Freeman Road subdivisions: 4001 West Mercer Way

To: Mercer Island Planning and Development Department:

Environmental Degradation and Water Damage Pose Severe Slide Risk

EVALUATION OF FREEMAN AVENUE STORMWATER ISSUES

Figure 5

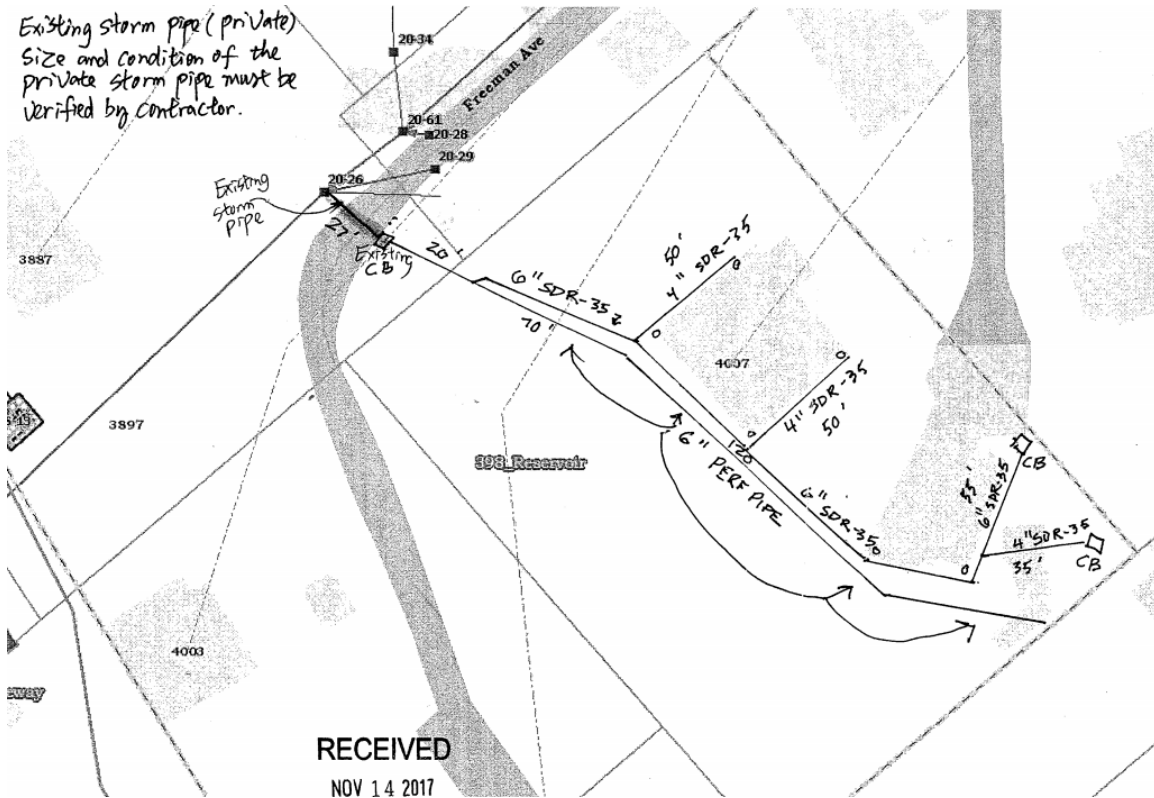
Here is the design. Figure 8.

As I reviewed the diagram, I wondered why the drainage was so far East of the hillside, as far as 30' away in parts.

Figure 1: Illustration of stormwater infrastructure adjacent to subject properties.

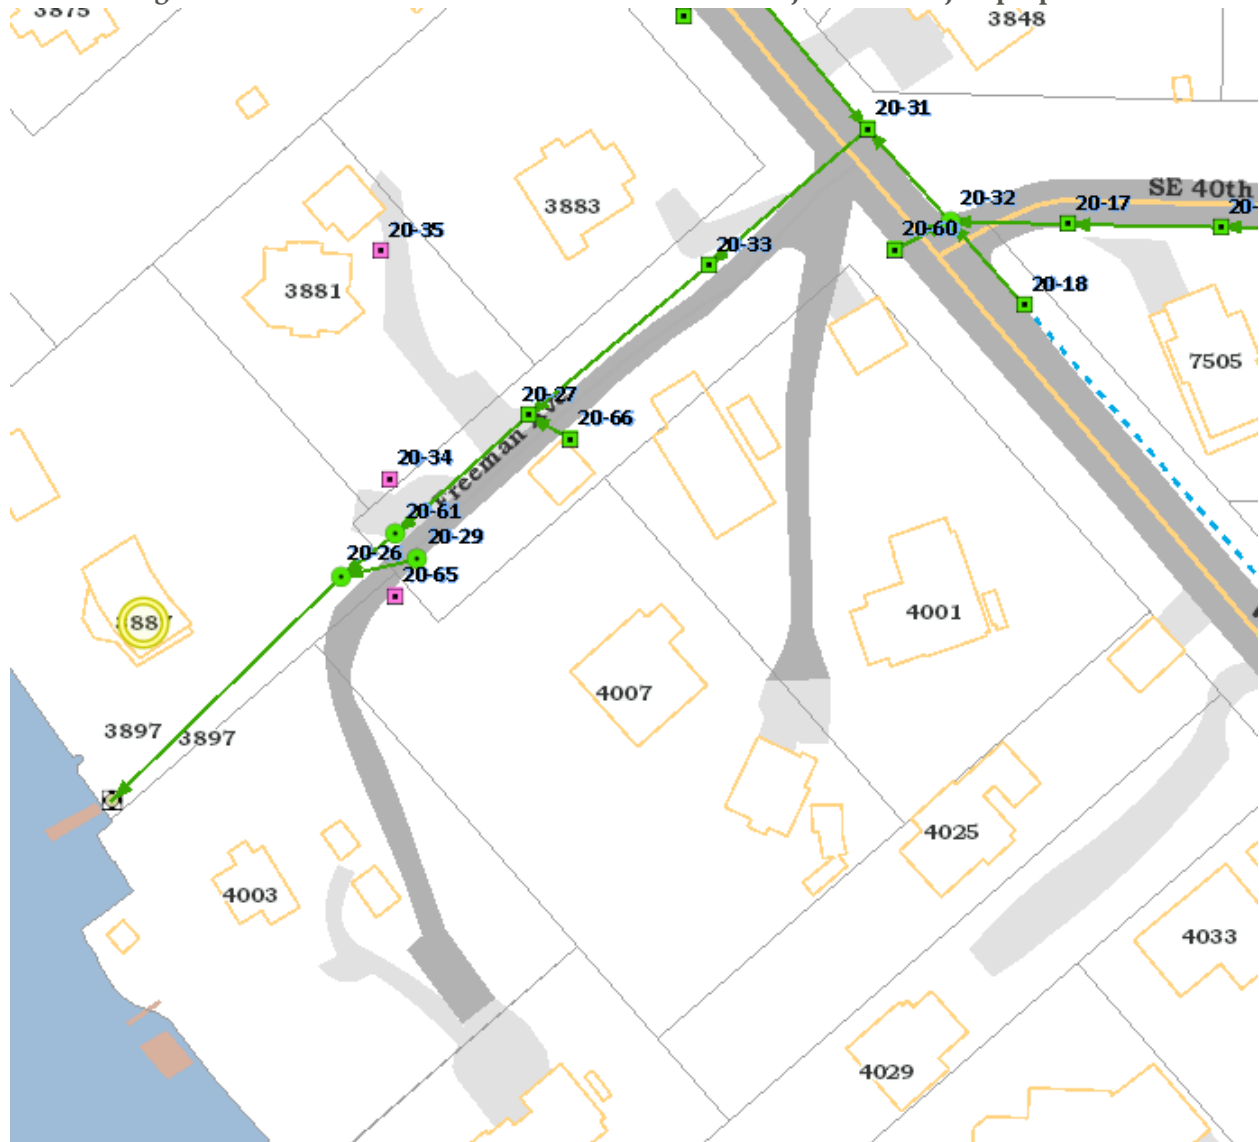
There were a total of 18 trees evaluated on three properties, 4000, 4003, and 4007 W Mercer Way. The stormwater benefits provided by trees at these three properties intercept an estimated 34,376 gallons of rainfall each year and help to avoid an estimated 24,130 gallons per year into adjacent stormwater systems (Table 1). **The anticipated removal of seven (7) mature trees at 4000 W Mercer Way could increase runoff by an estimated 14,237 gallons annually into the stormwater system along Freeman Ave** (Asset ID SD-GM-05189, Figure 1).
